FIELD INSPECTION

T	
Project Name:	Mountain Valley Pipeline	Inspector:	Matthew Grant
Inspection Date:	Wednesday, August 28, 2019	Project Contact:	Brian Clauto
Spread: Roanoke Co. MP240 12690+29-12712 ATWS1224 &1225 ARO 280 Montgomery Co. MP234.3-235.4 St12374+50-12433+80	Spread H	Weather (Wet/Dry/Rain):	Dry
STAGE OF CONSTRUCTION: (Check all that apply)			
Clearing	Rough Grading	Trench Excavation	Pipe Assembly, Testing & Installation
Backfilling and Grade	e Restoration	& Stabilization	Other: Dormant
Are controls installed and implemented in accordance with the approved erosion and sediment control plan and stormwater management plans? Are all control measures properly maintained in effective operating condition in accordance with good engineering practices and, where applicable, manufacturer specifications?			
Comments: Inspected designated streams included: S-0016, NN-17 St12417+00 sump lacks adequate capacity St12418+00 sump lacks adequate capacity St12690+29-St12712 lacks stabilization Recommend Corrective Action: Maintain and install all controls per the approved plan and specs

FIELD INSPECTION PHOTO LOG

Project Name: Mountain Valley Pipeline Date: Wednesday, August 28, 2019

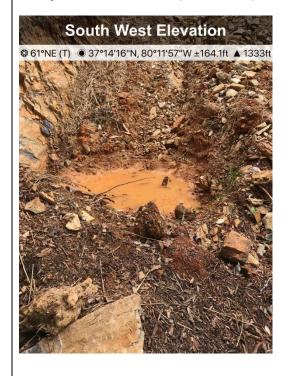
Fig. 3 St12417+00 sump lacks adequate capacity
